**Response to Comments on SEPA Checklist**

SR 202 Sammamish River Bridge and Road Improvement Project, City of Woodinville

PLANTING PLAN - BRIDGE 202/35

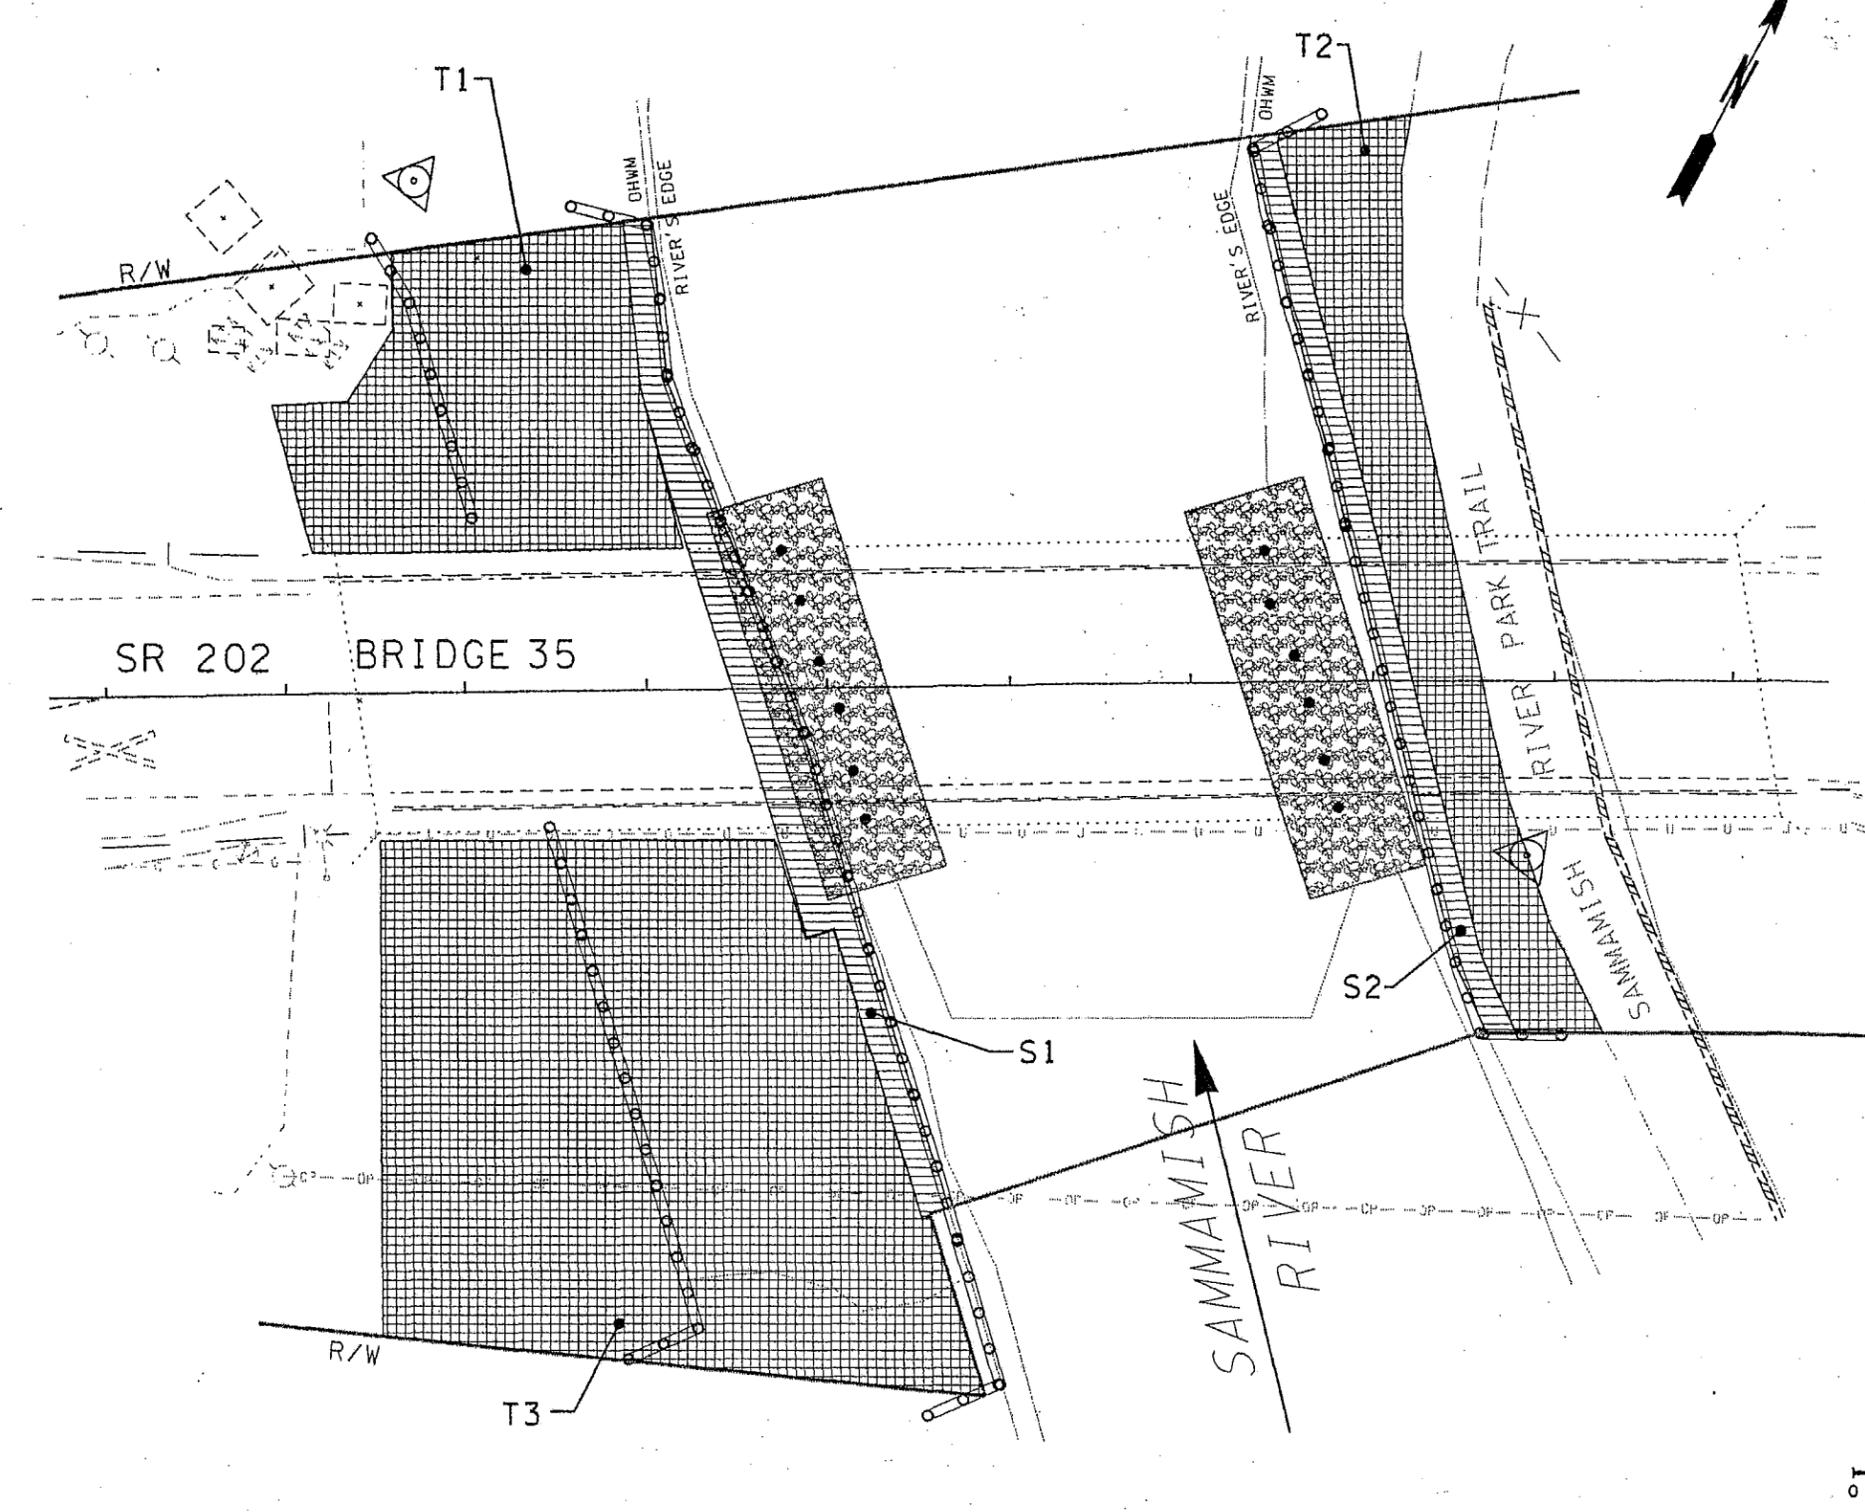
Agency	Comment	Response
<p>The Muckleshoot Indian Tribe reviewed the City's responses to comments above, and submitted the following additional comments to the City via email on July 27, 2012.</p>		
<p>Muckleshoot Indian Tribe</p> <div data-bbox="136 324 283 552" style="border: 1px solid black; padding: 2px; width: fit-content;"> <p>EXHIBIT 22 PAGE 6 OF 26</p> </div>	<p>1. Per the City's responses, the project will affect the majority of the 2003 WSDOT mitigation site. If this is the case, then the City should verify that this will be allowed under any Corps permit issued for the WSDOT project and that the propose mitigation is sufficient.</p>	<p>Thank you for the comment. We investigated this issue by contacting John Maas, WSDOT's Northwest Region Environmental Compliance Manager for information about the 2003 mitigation project and any related permits and conditions. John provided us with the attached Planting Plan from their plan sheets for the <i>2003 Sammamish River Bridges 203/35 and 202/38 Scour Project</i> which shows the boundaries of their mitigation project at the site, the plant species installed, and quantities. Our project will affect that portion of the 2003 WSDOT mitigation site located upstream (south) of the existing bridge on the west side river (labeled as S1 and T3 in the attached 2003 WSDOT Planting Plan).</p>
